APPLICATION NUMBER: 18/0293

PROPOSAL: DEVELOPMENT OF 206NO. RESIDENTIAL UNITS, INTERNAL ROAD NETWORKS, PARKING, LANDSCAPING AND ASSOCIATED WORKS AFFECTING PUBLIC RIGHT OF WAY 407/1

SITE: Land To South Of Glan Usk Primary School, Herbert Road, Newport

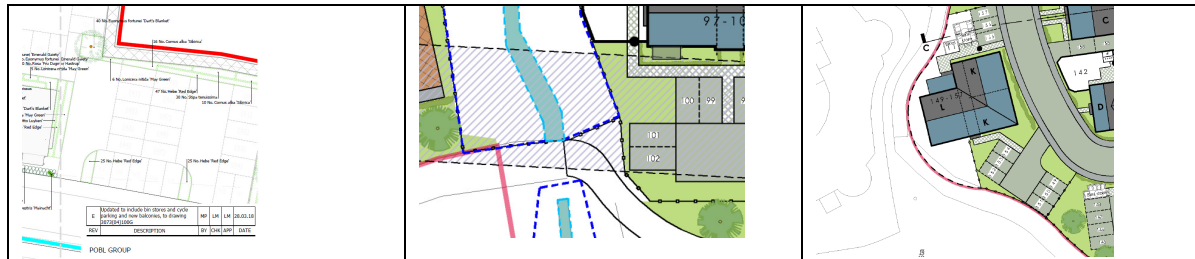
1. Boundaries to the east are defined by gabions or earth bank retaining walls, generally these are 2.5m high structures topped by a 1.8m fence. Where these are within rear gardens no planting is proposed (see extract below), where these are visible to the public realm planting is proposed but often this is mass planting of low evergreen shrubs such as *Lonicera nitida* or *Prunus Otto Luyken* (refer plans LA4 and LA6). The development density has presumably resulted in the need for retaining structures. I feel the planting plan should address the visual impact of these retaining structures and also identify any opportunities to provide a Green Infrastructure route along the site boundary.
